American
Petroleum
Institute

February 13, 2023

RE: Proposed Standards of Performance for New, Reconstructed, and Modified Sources and Emissions Guidelines for Existing Sources: Oil and Natural Gas Sector Climate Review, Including Appendix K and Social Cost of Greenhouse Gases

API Comments on EPA's Proposed "Standards of Performance for New, Reconstructed, and Modified Sources and Emissions Guidelines for Existing Sources: Oil and Natural Gas Sector Climate Review"

Figure 1. Multi-layered Approach for Leak Detection

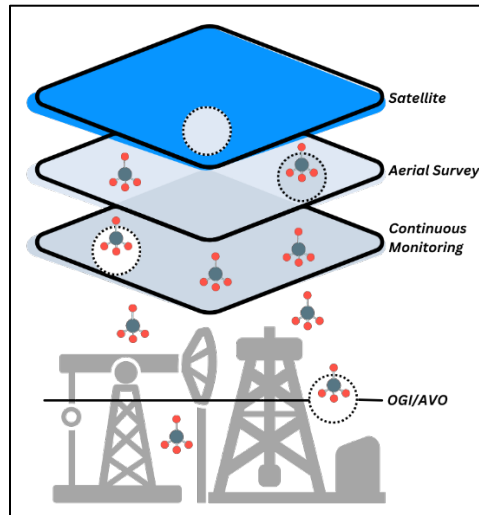
3.1.6 Framework for alternative leak detection technologies should allow multiple technologies, including satellite, to be combined. More combinations of technologies should be added to the proposed periodic screening matrices.

Overall, API believes that allowing the use of a combination of alternative leak detection technologies can be effective to find and fix leaks. This alternative approach recognizes that each leak detection technology (AVO, OGI, Method 21, periodic screening, or continuous monitoring) has strengths and weaknesses in terms of detection threshold, proximity to the source, localization performance, deployment frequency, and costs. For example, ground-based OGI has a low detection threshold and localizes the leak to a particular component but requires proximity to the source and is infeasible to deploy at higher frequencies. Whereas satellites, aerial and continuous technologies can be deployed more frequently than ground-based OGI, the increased distance from the source may not detect leaks on the component level. With these remote detection technologies, resources can be deployed more efficiently to repair leaks – operators would only need to visit sites with detected emissions to make repairs whereas using only OGI surveys require operators to visit each site but could result in no detected emissions. A continuous monitoring system can quickly detect a leak and depending on sensor location, provide an approximate location, but may not fully visualize its location like a plume map from a satellite or aerial survey. In other words, no individual leak detection technology offers a perfect solution.

By allowing the option for a combination of these various technologies into a single monitoring plan or framework, the weaknesses of one technology can be offset by the strengths of another, and the selected technologies work together to improve leak detection and reduce emissions in a flexible and cost-effective manner. Technologies can be combined such that larger emissions are quickly detected, and technologies that detect smaller emissions are deployed less frequently. Finding and fixing the biggest leaks quickly can greatly impact the overall emission reductions.

- **API recommends that continuous monitoring (see also Comment 3.4.1) and satellite technology be included as options directly in the matrices in combination with the periodic survey with and without annual OGI.** In other words, combinations like “Quarterly + Weekly Satellite + Annual OGI”, “Quarterly + Weekly Satellite”, “Quarterly + Continuous + Annual OGI”, and “Quarterly + Continuous” should be modeled and added to the periodic screening matrices with appropriate detection thresholds for the screening technology. Satellite technology would be defined with a ≤ 100 kg/hr detection threshold and a weekly frequency. Having frequent satellite surveys will allow reducing the number of periodic surveys per year for a given detection threshold with and without an annual OGI survey.

- **Separately, we would also welcome an additional optional and flexible framework independent from the periodic screening matrices and case-by-case AMEL process where an operator can develop a monitoring plan for each basin/site with their chosen suite of EPA-approved technologies via EPA-approved modeling.** Similar to EPA’s proposed clearinghouse approach to approving alternative screening technologies, EPA could evaluate and approve different modeling platforms for use in developing monitoring plans. Modeling could be refined over time based on data generated through the monitoring plan. The initial modeling should represent the highest emissions level since emissions should decrease over time as NSPS OOOOb and EG OOOOc are implemented over the next several years. This approach would both allow the technology to mature over time and a streamlined approach to alternative modeling compared to the existing case-by-case AMEL process.

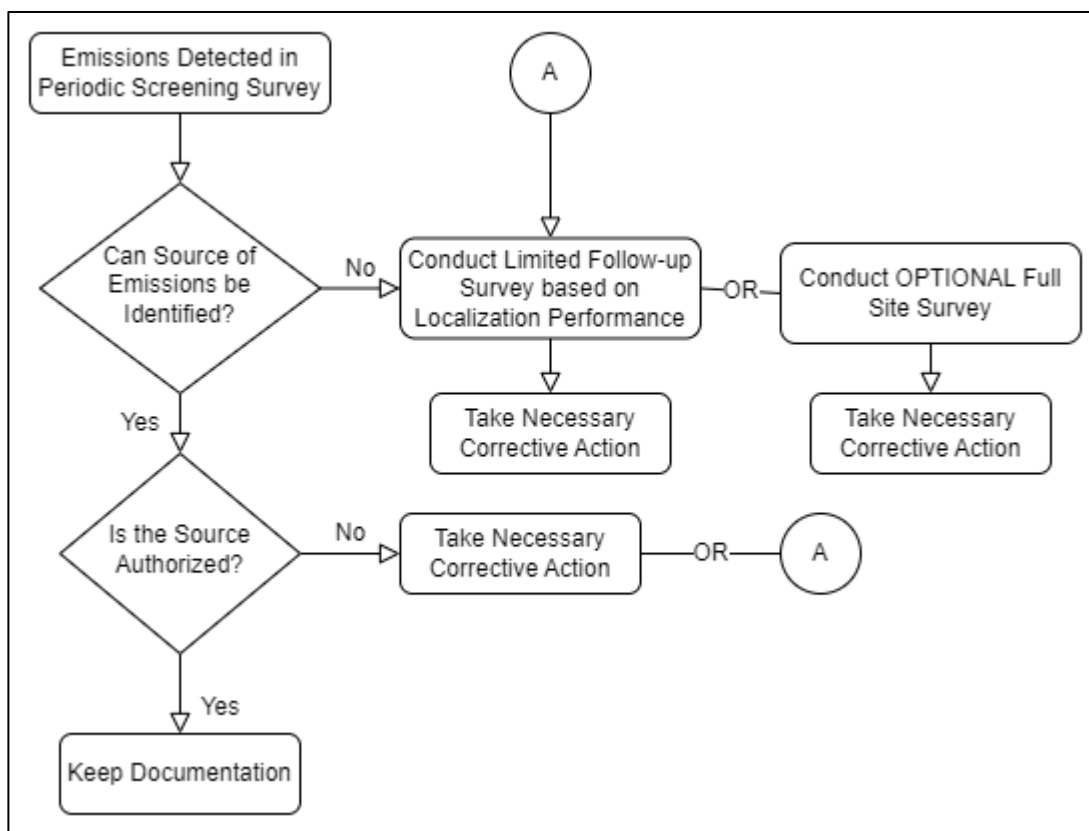
While API acknowledges EPA's proposed matrices of minimum detection thresholds and frequencies, they do not incentivize the use of alternative technology as proposed. To have the same monitoring frequency as OGI, alternative technology must have a minimum detection threshold of ≤ 1 kg/hr for both quarterly OGI and semiannual OGI requirements. This proposed performance level effectively limits the alternative technology options as operators are more likely to use technology with the same or less frequent monitoring than OGI. The proposed performance standards in the matrices are more stringent than needed in part because EPA's FEAST model overestimates the effectiveness of AVO and OGI inspections as mentioned previously in Comment 3.1.4. To incentivize the use of alternative technologies, API believes that quarterly screening surveys with an annual OGI survey should equate to a minimum detection threshold of ≤ 10 kg/hr for sites subject to quarterly OGI; the rest of the matrices would be adjusted accordingly. Supporting modeling analysis may be provided in subsequent comments.

These matrices also do not appear to be based primarily on the minimum leak detection threshold. In proposed Table 1 to Subpart OOOOb of Part 60, the minimum detection threshold is proportional to screening frequency between monthly and bimonthly frequencies without annual OGI (i.e., minimum detection threshold is halved for twice as frequent monitoring). However, if an annual OGI survey is included with monthly and bimonthly screening surveys, the minimum detection threshold is decreased by a factor of 3 instead of the expected 2 (i.e., monthly + annual OGI requires 30 kg/hr detection while bimonthly + annual OGI requires 10 kg/hr instead of the expected 20 kg/hr). While frequency and detection threshold are not the only parts of a leak detection program, one would expect frequency and detection thresholds to be roughly proportional assuming that other aspects of the leak detection program (e.g., repair timelines) are constant.
